Field Remedy: 1467

Subject: **Rear Lamps - Water ingress**

Speedster 2000...2002 Z22SE

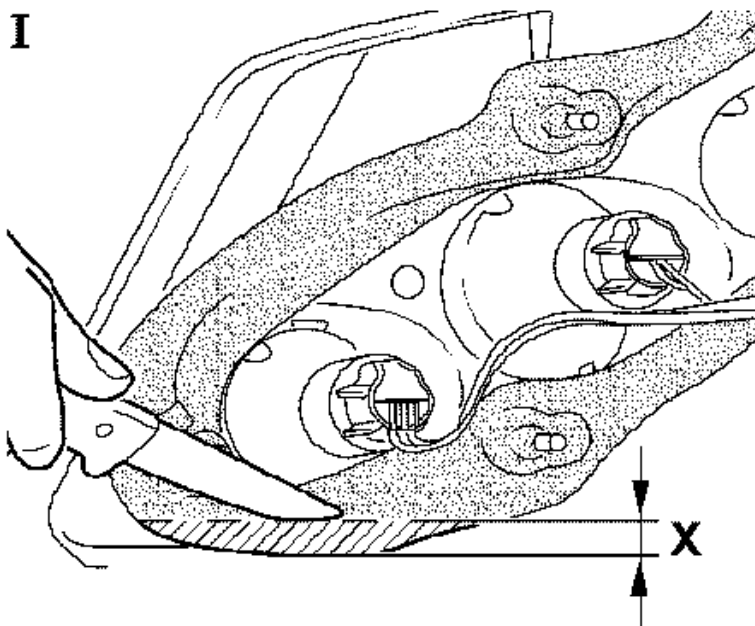
Complaint: Water ingress on rear lamps.

Cause: Poor position of sealing rear light.

In case of customer complaint cut and remove a foam rubber section of rear lamps.

1. Remove rear lamps
 - see working procedure "Rear Lamp, Remove and Install", group "N", Service Instruction Speedster.
2. Cut and remove foam rubber section "x" of rear lamps with suitable tool (picture I, X=20 mm).
